# Tice River Homes

## Legacy

model  
36-01

**GROUND FLOOR ELEV. 'A'**

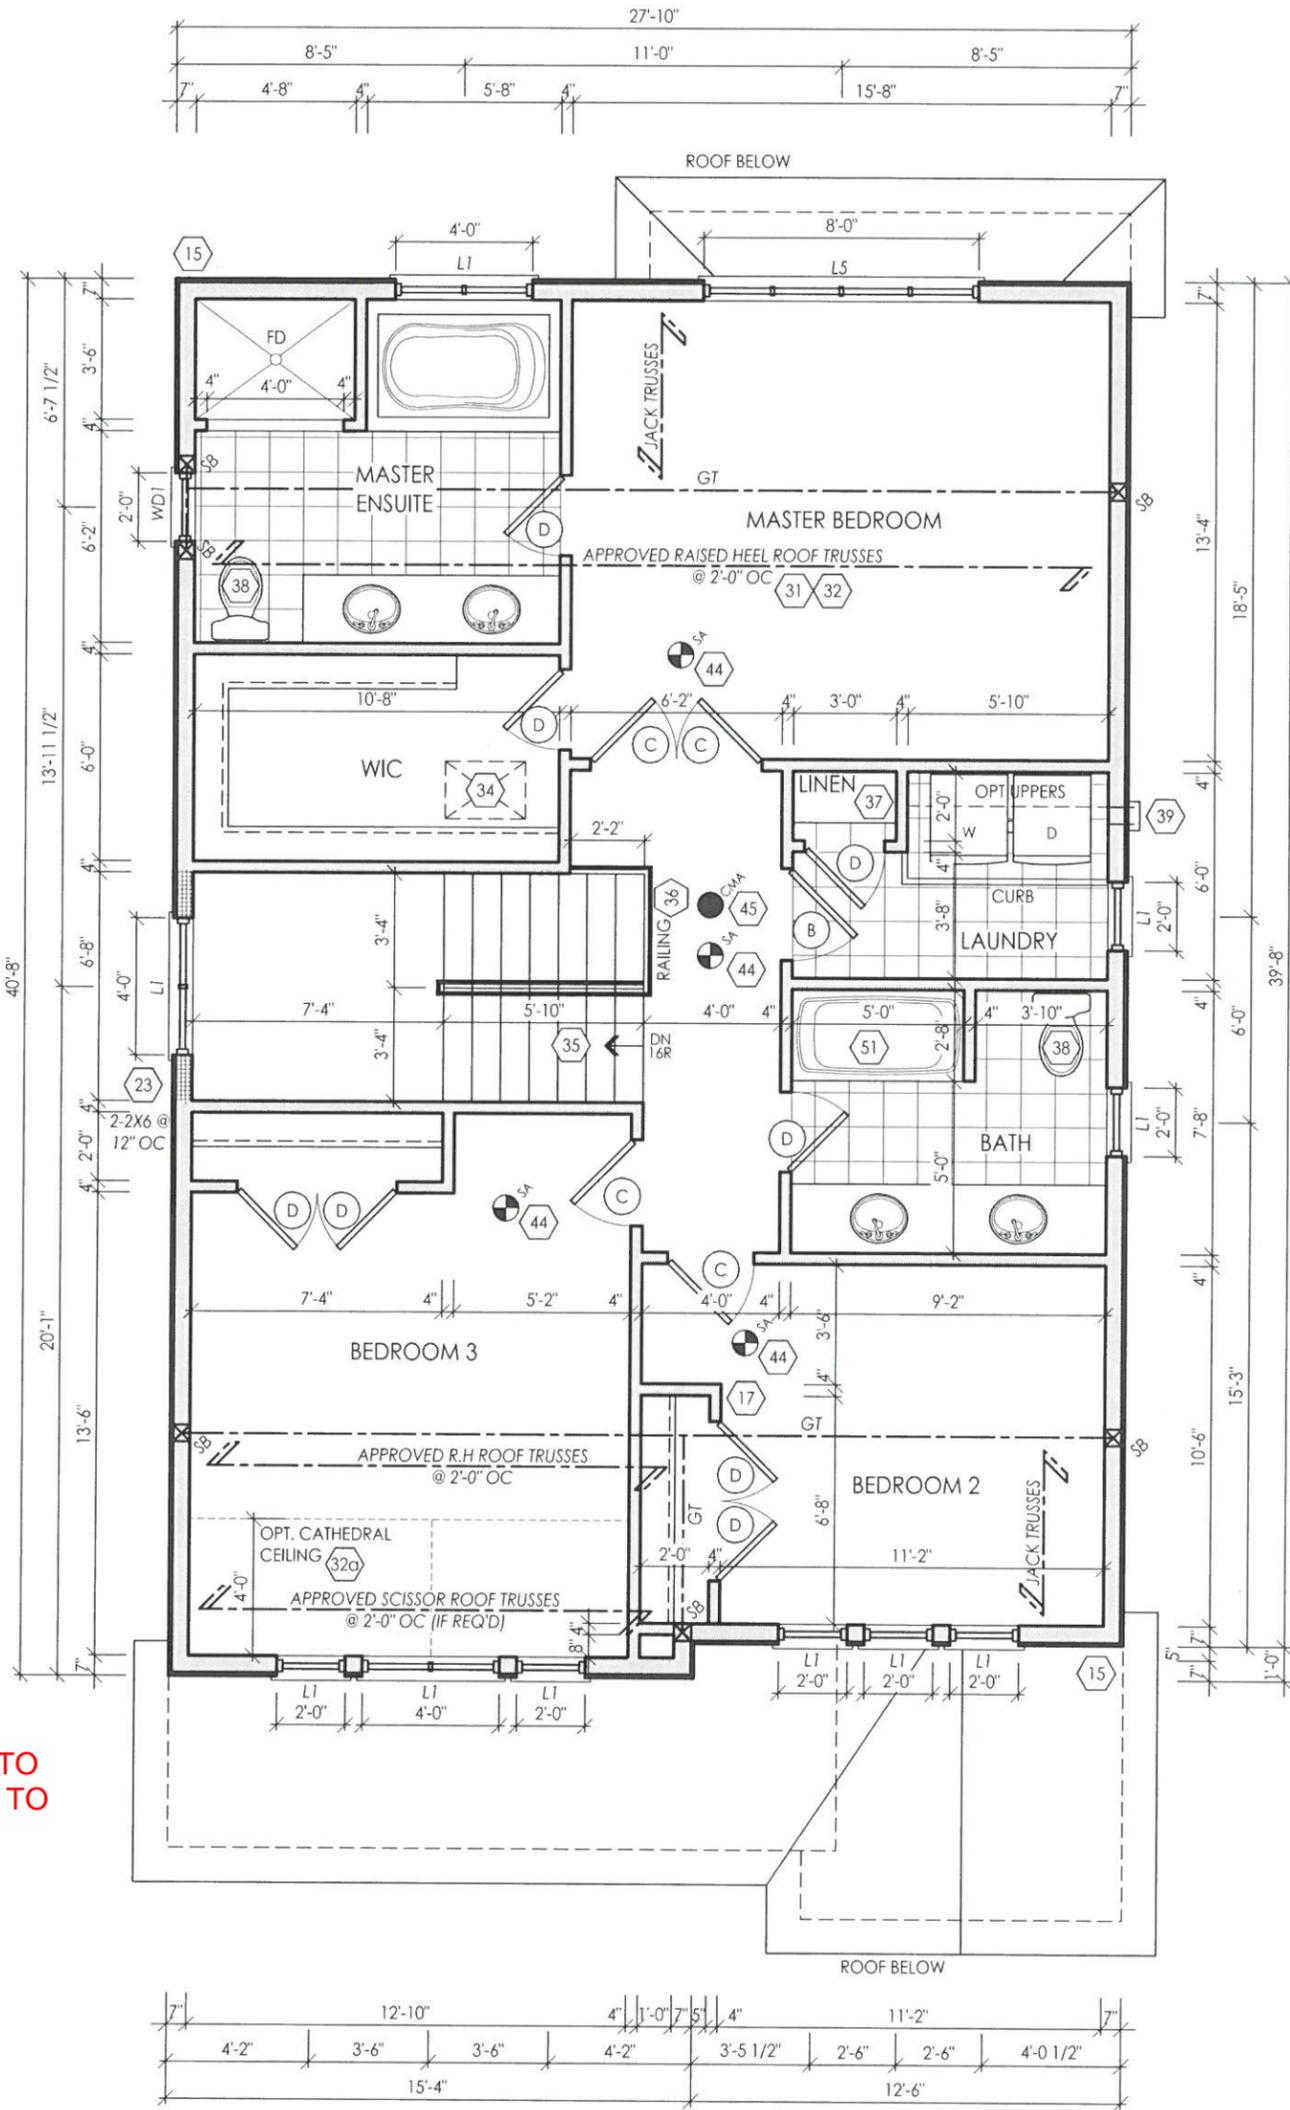
MAX PROJECTION INTO REQD SIDE YARD 0.3M

KITCHEN/BATH FLOORS AS PER 9.30.1.2

BEAM/FLOOR CONNECTION DETAILS REQD AT FRAMING INSPECTION

GARAGE WALL AND CEILING TO BE GAS PROOFED

GARAGE MAN DOOR TO BE SELF CLOSING, LATCHING AND WEATHER STRIPPED

SECOND FLOOR ELEV. 'A'

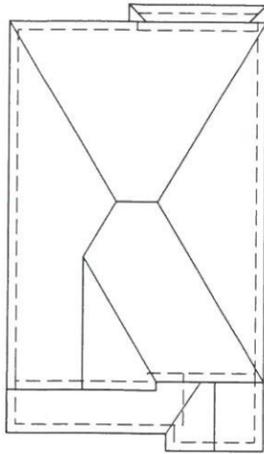
ENGINEERED FLOOR LAYOUT, TRUSSES AND LINTELS TO BE SUBMITTED PRIOR TO FRAMING. DESIGNER TO COMPLETE RESPONSIBILITY REVIEW FORM AND TO BE SUBMITTED WITH TRUSSES, FLOOR AND LINTEL DOCUMENTS

TALL WALL AND WINDOW OVER LANDING MUST COMPLY WITH OBC

MAIN BATH TO HAVE GRAB BAR BLOCKING

ALL POINT LOADS TO BE TRANSFERRED TO FDN
